Service Bulletin

Subject: Front Tire Front Air Deflector Fastener Length Differences

Brand:	Model:	Model Year:		VIN:		Engine:	Transmission:
		from	to	from	to		
Chevrolet	Volt	2016	2016			All	All

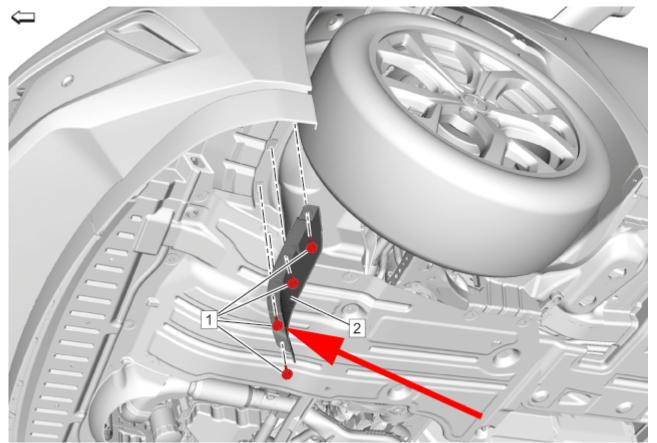
Condition	When performing a PDI, or if removing the left front tire front air deflector or the front bumper fascia center air deflector, the incorrect length screw may have been provided for installation.		
	If a longer screw is installed in the incorrect position of the left front tire front air deflector, the longer screw may come in contact with the battery coolant hose.

During PDI installation or replacement/removal of the left front tire front air deflector (2), use shorter screw (Part Number 11570498) instead of the possible provided longer screw in the location pictured above.

Note: The shorter screw is only needed to be used in replacement of the longer screw on the left side of the vehicle.
